June 1996

TECHNICAL SUPPORT FOR PROPOSED  
MODIFICATION TO THE CHURCH ROCK SITE  
TAILINGS RECLAMATION PLAN  
NRC LICENSE SUA-1475

REVISION 1

United Nuclear Corporation

DATE:	8-20-96	FIGURE 1	DRAWING NUMBER
SCALE:			88-080-E1055

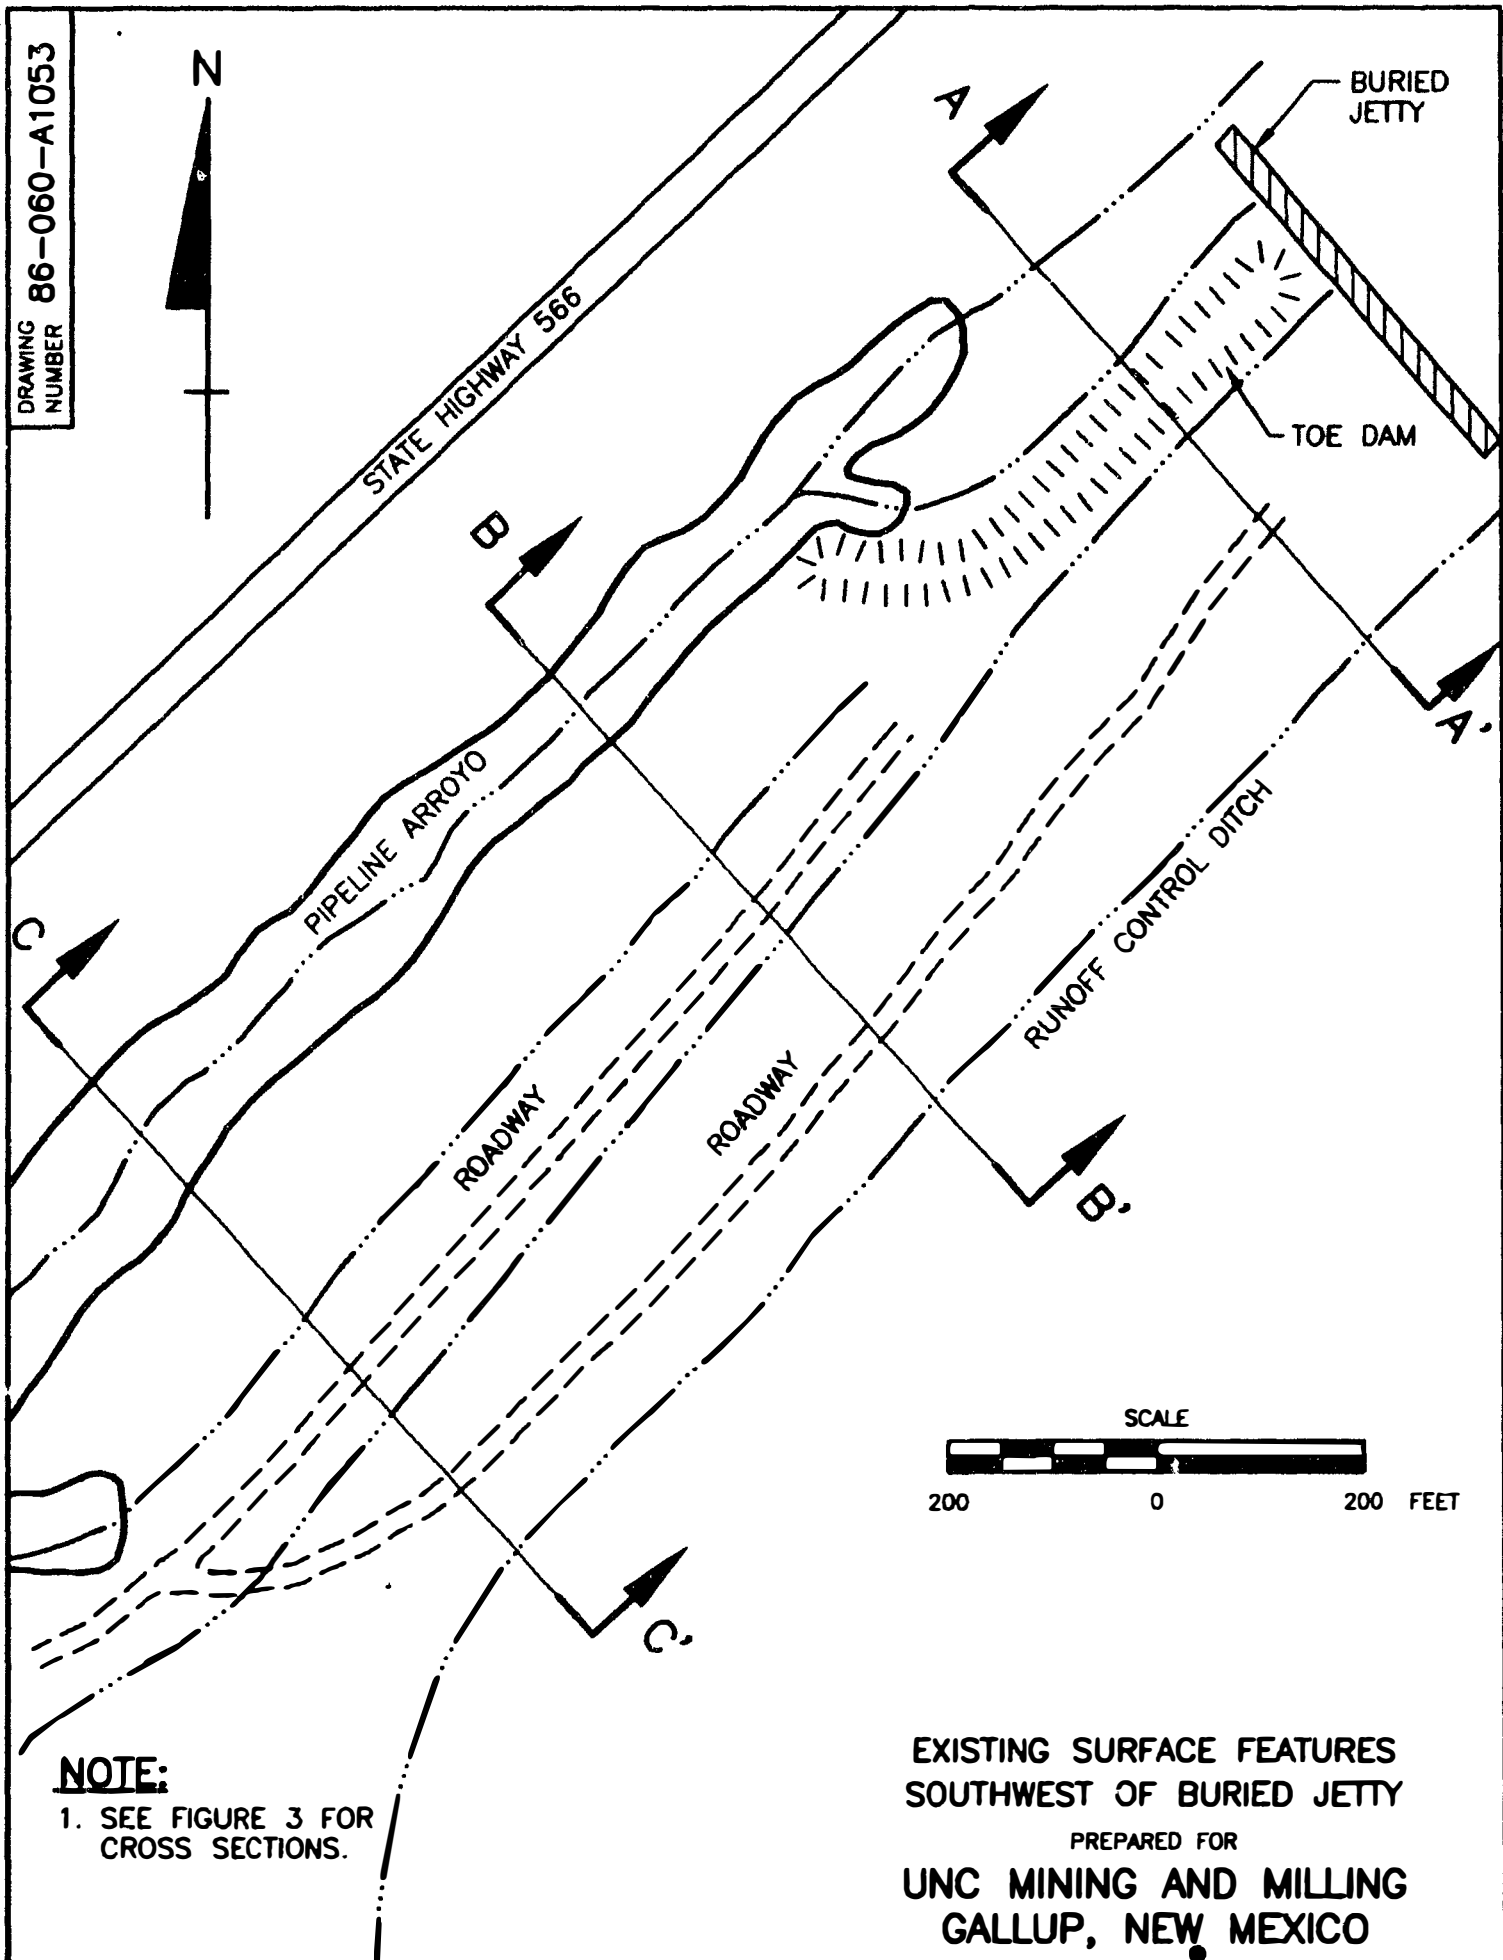
This proposed modification addresses regrading of the area shown on Figure 1, which is located west of the reclaimed tailings disposal area and south of the Buried Jetty. The engineered contours require that a large volume be moved. These contours were developed to promote positive drainage away from the tailings area. However, review of the existing surface features indicates that the existing roadways and natural drainage channels actually provide equal or better long-term protection for the tailings. The existing surface features direct runoff into flow paths parallel to the face of the tailings, thus inhibiting the development of headward erosion toward the reclaimed tailings pile.

Figure 1 shows that the engineered contours required by the Reclamation Plan result in a smooth slope from the tailings to the Pipeline Arroyo. As shown on Figure 2, this area is currently occupied by two roadways and portions of a toe dam which was built in 1979 to protect the tailings impoundment. These features, with the runoff control ditch, produce a drainage pattern that results in several small channels directing runoff parallel to the face of the tailings pile. These channels flow southwest to discharge into the Pipeline Arroyo.

Also, the depression located south of the South Cell Drainage Channel (SCDC), highlighted on Figure 1, will be backfilled with material excavated from the SCDC. The backfill will be contoured to maintain the natural drainage toward the SCDC and the Pipeline Arroyo.

It is proposed that the existing roadways and drainage channels be left in place. The channels will be cleaned out, and any existing obstructions will be removed to ensure that positive drainage exists along the entire length of each channel. The upper ends of the drainage channels adjacent to the buried jetty will be regraded as necessary to maintain a gradual slope from the top of the buried jetty to the channel bottoms.

FIGURE 3

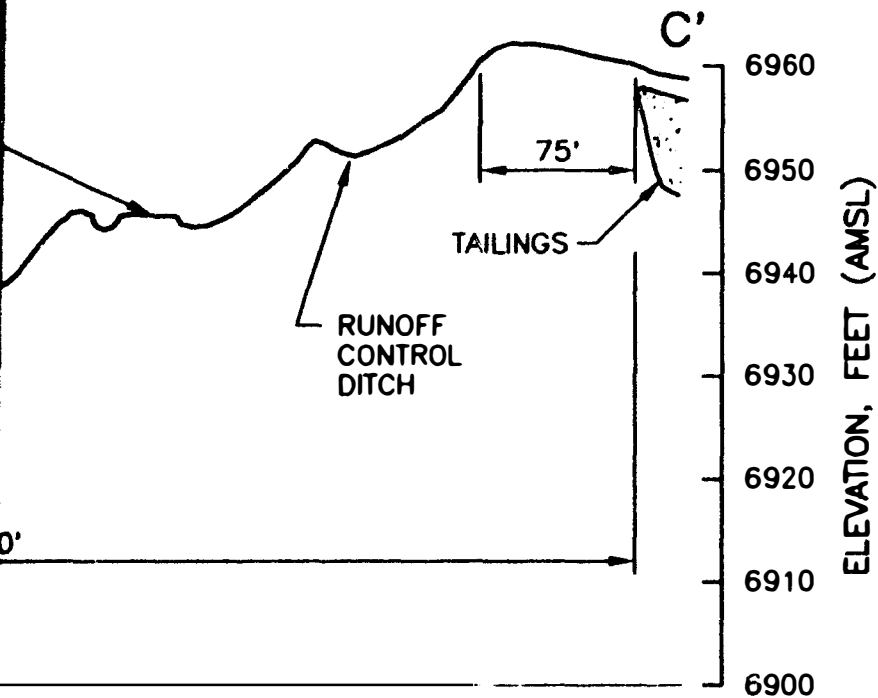
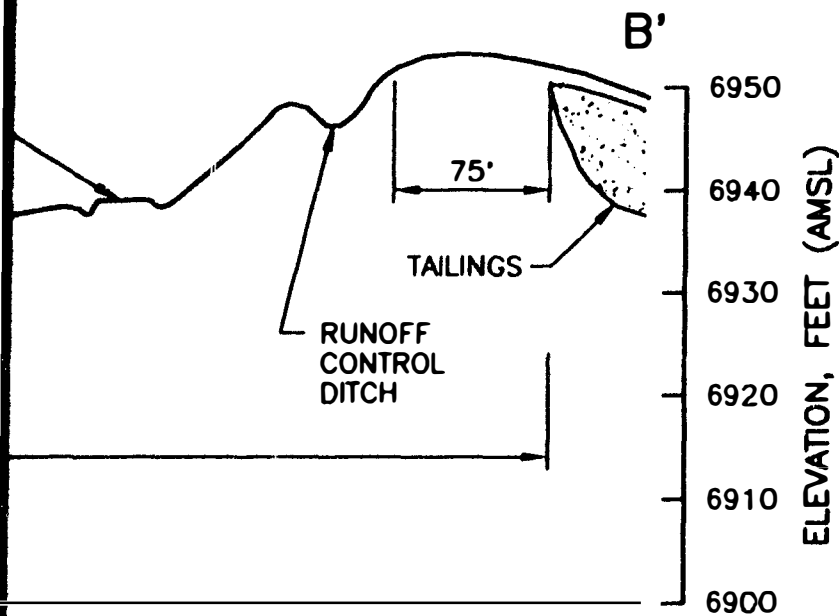
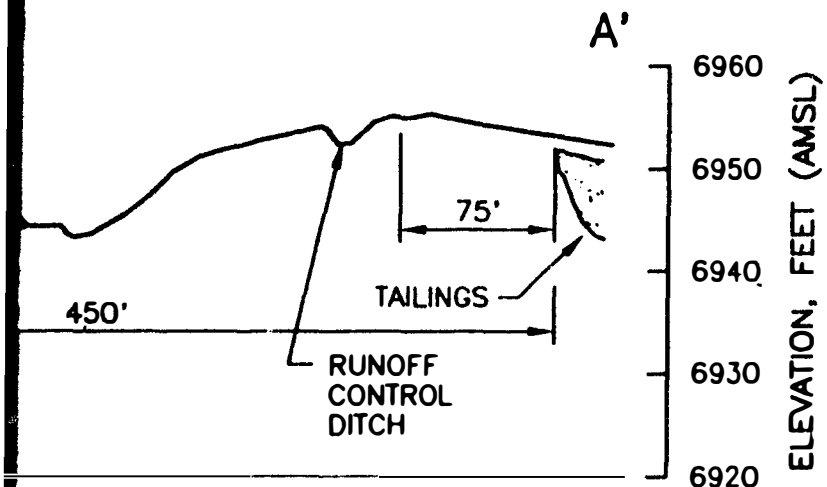
The existing channels have a beneficial effect because, by promoting flow parallel to the tailings embankment, headward erosion into the tailings and the development of gullies in the reclaimed cover is inhibited. Figure 3 shows a series of surface profiles which illustrate that the existing surface features produce a terraced effect, which slows and breaks up flow off the tailings embankment. The surface profiles also show that the probable maximum flood (PMF) flow is entirely contained in the channels farthest from the tailings and within the Pipeline Arroyo beyond a point about 300 feet southwest of the buried jetty. An additional safety factor is provided by the fact that the closest

tailings material contained in the reclaimed disposal area is located 75 to 100 feet from the outside edge of the reconfigured outslope of the reclaimed tailings embankment.

DATE:	8-7-91	FIGURE 5-1	DRAWING NUMBER
SCALE:			86-060-ED44

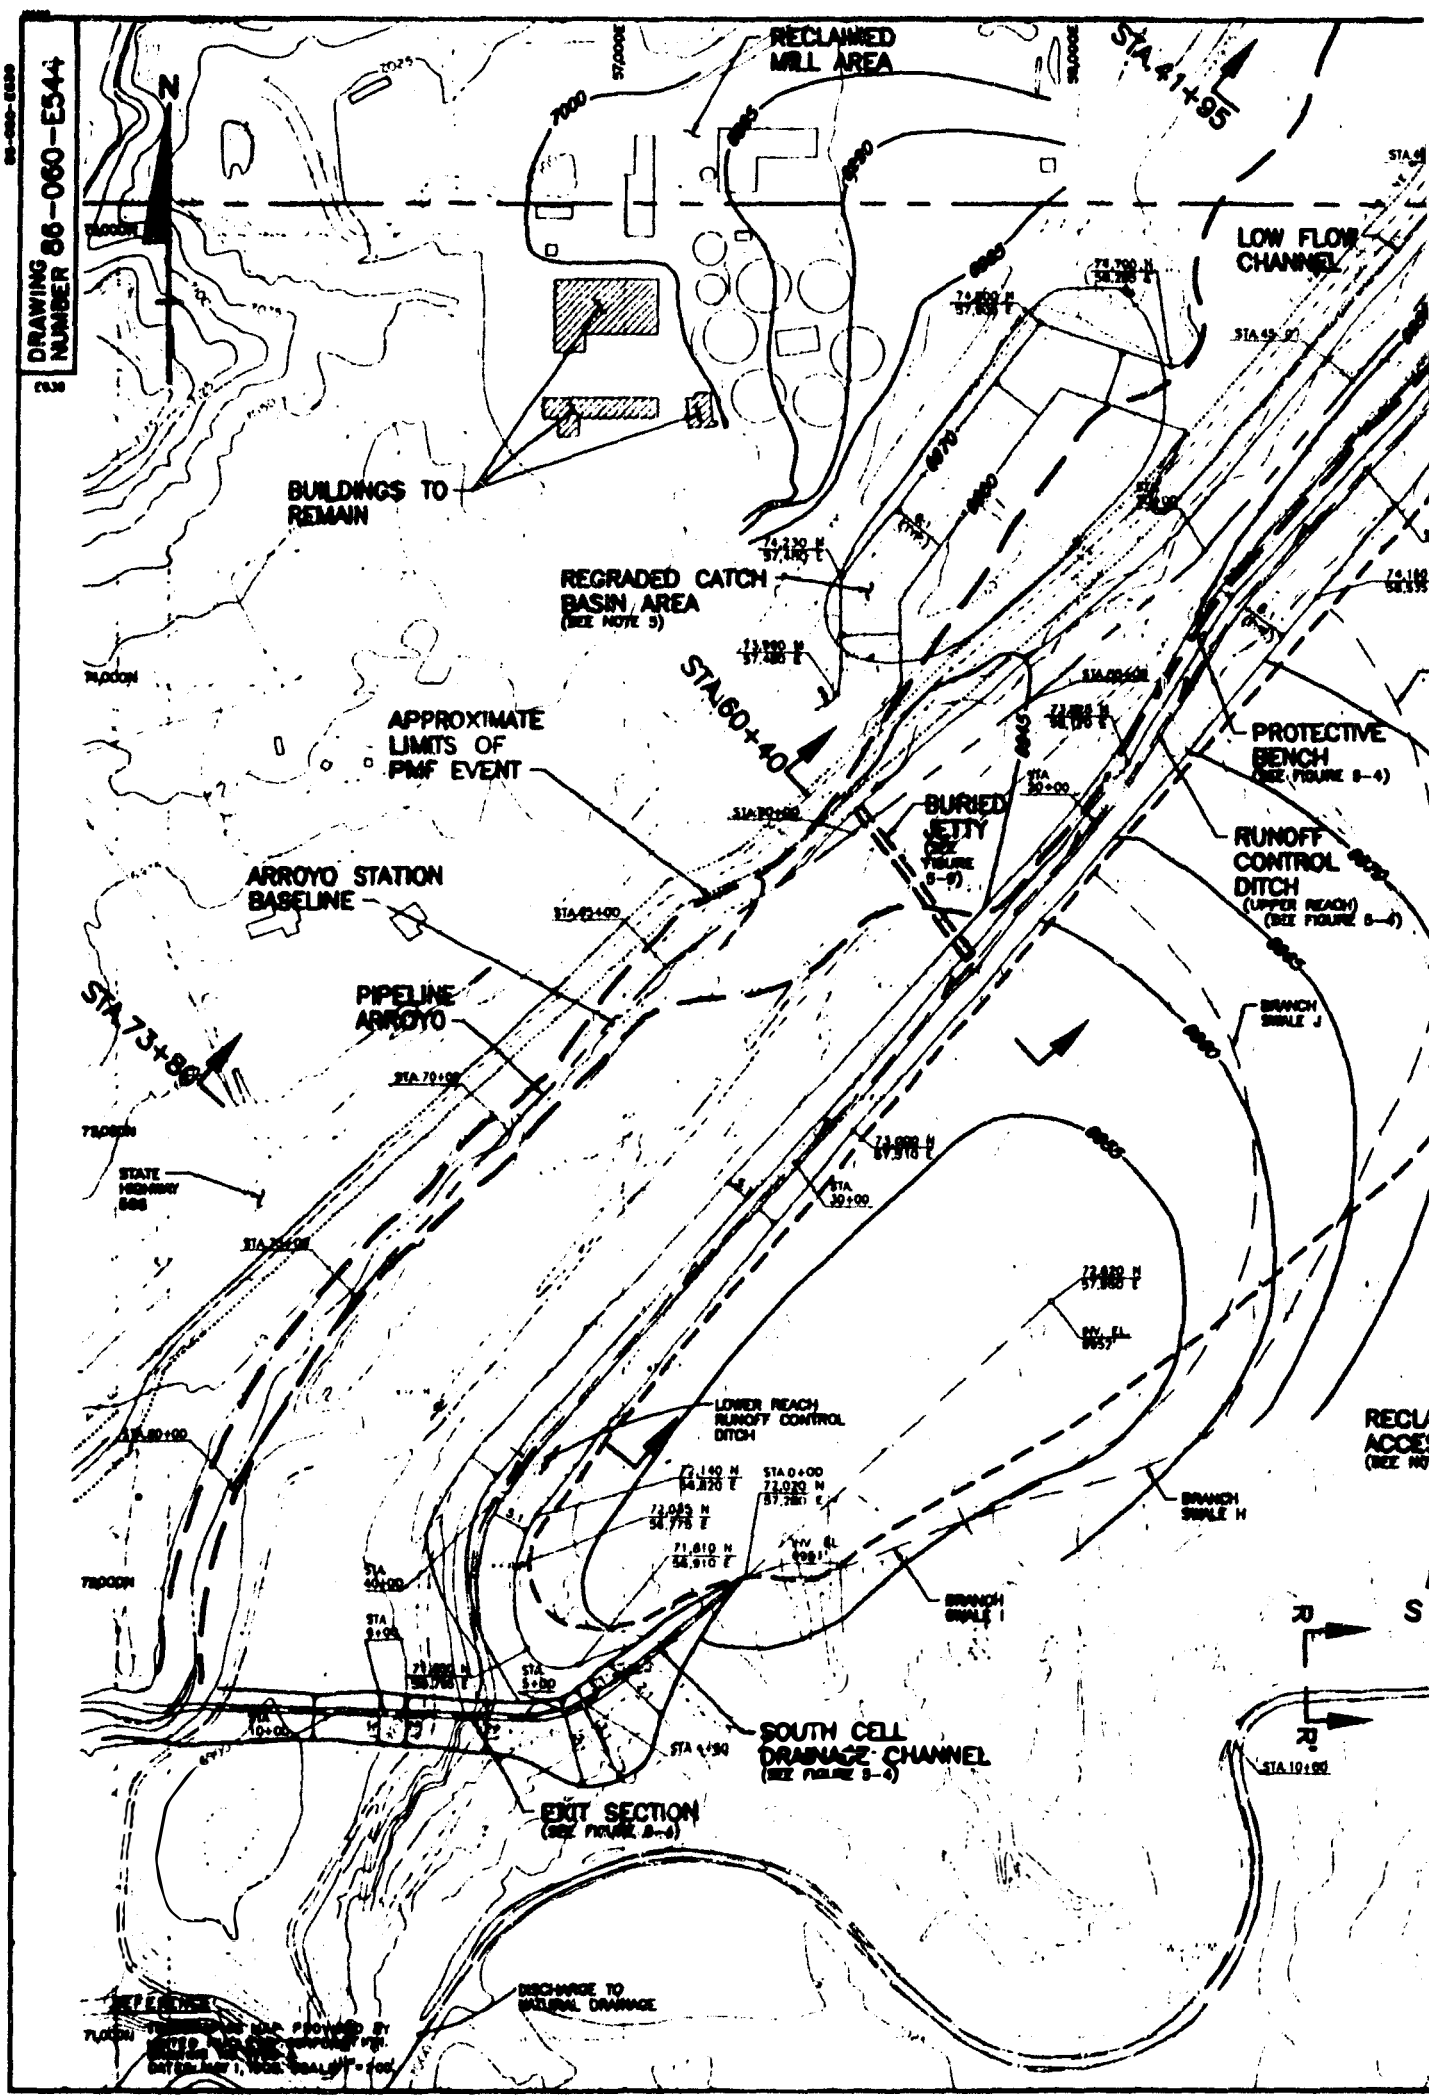
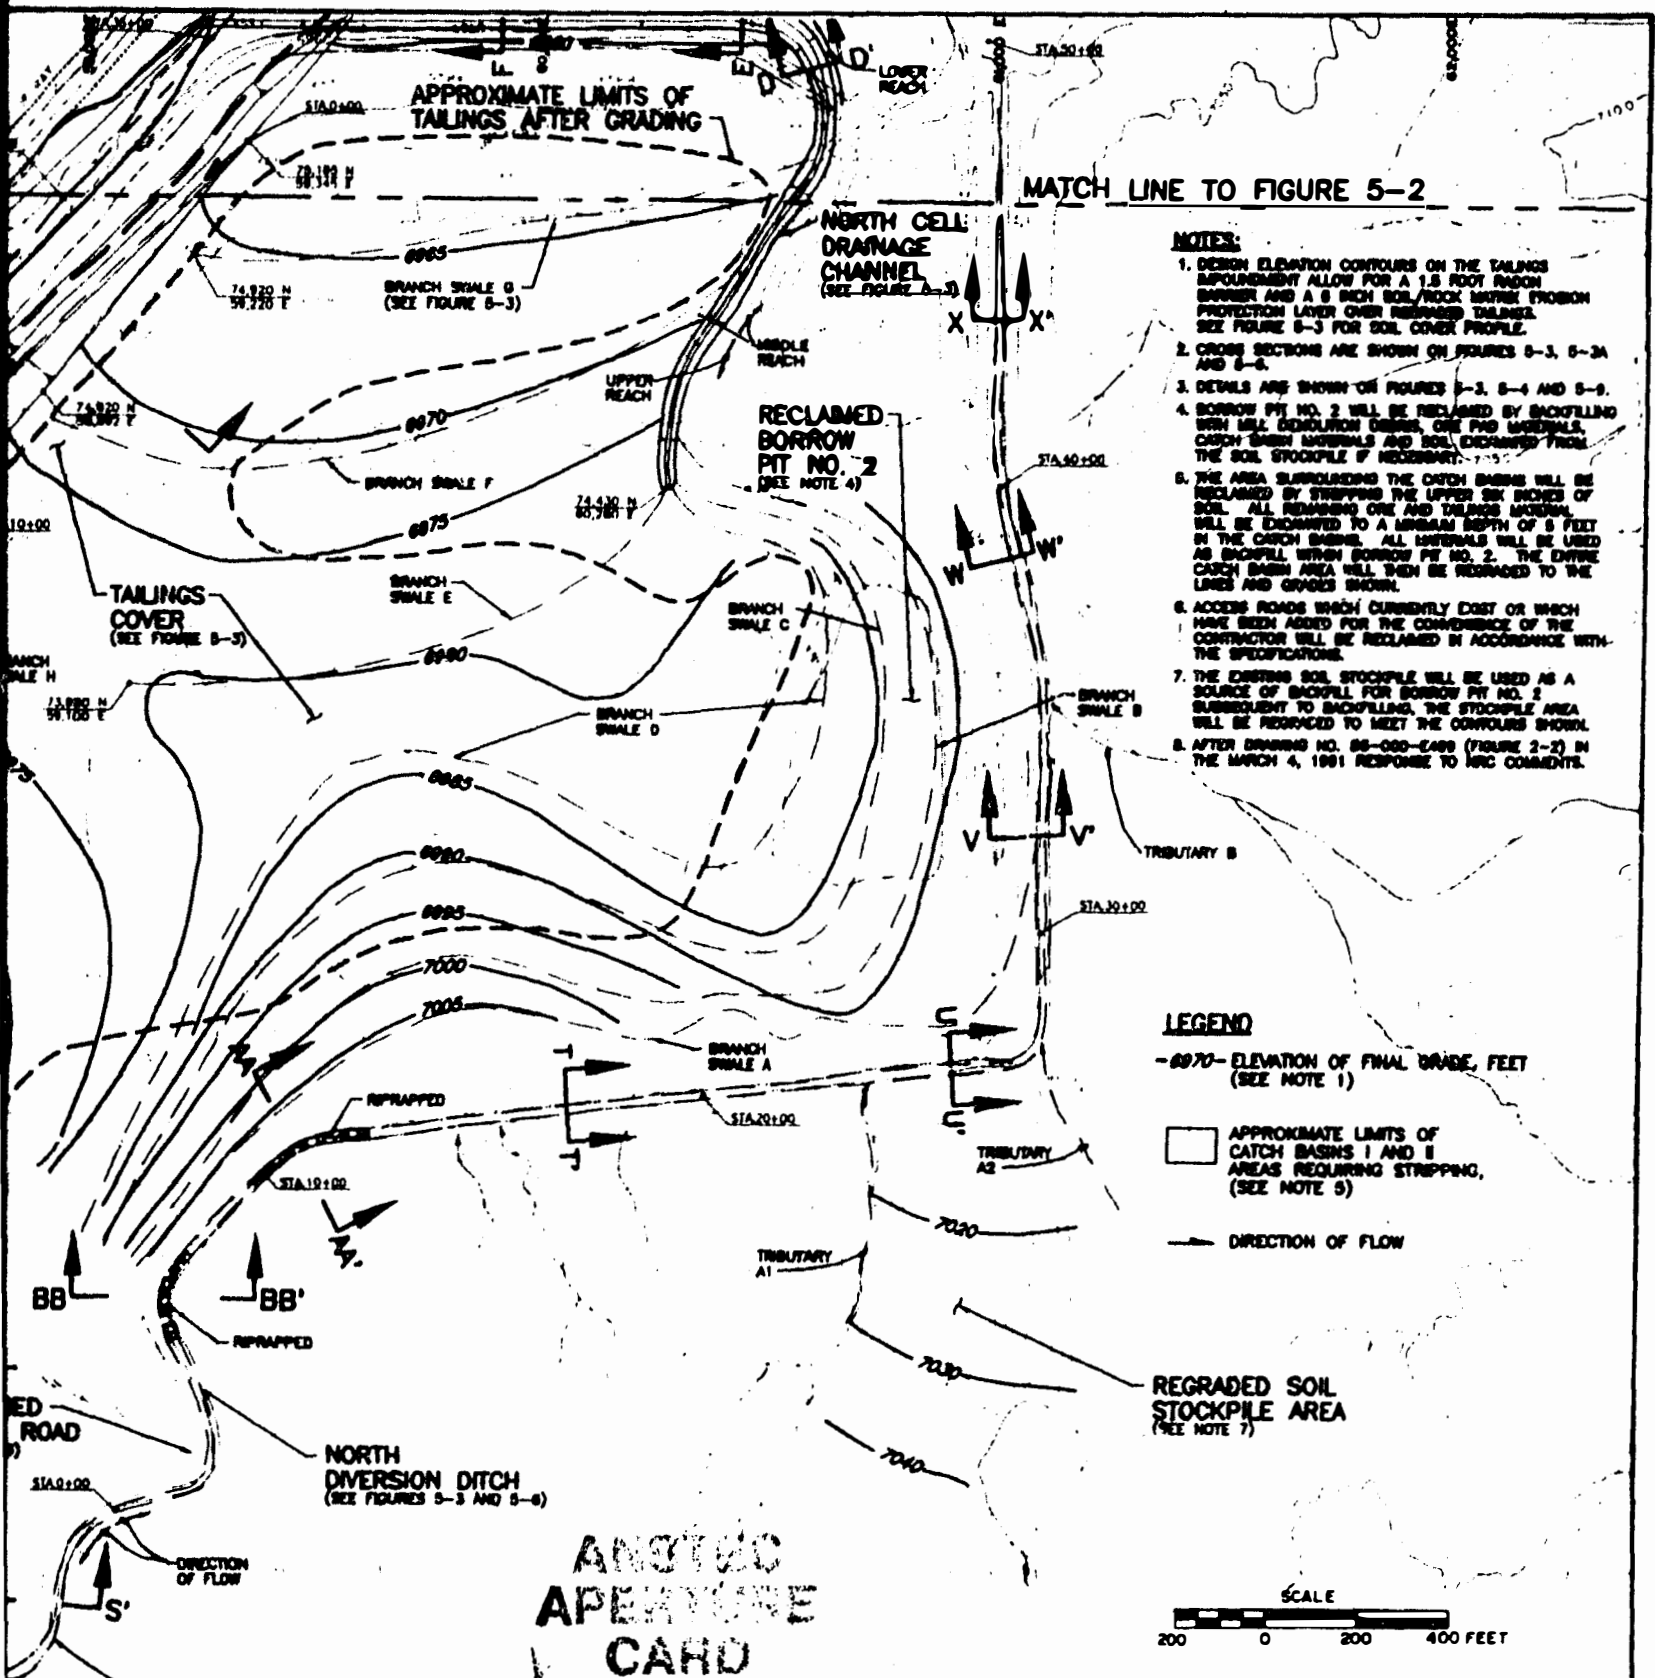
A revised Figure 5-1 is included as an attachment. The engineered contours for the area under discussion (shown on the original figure) have been removed, indicating that the existing contours will be left in place.
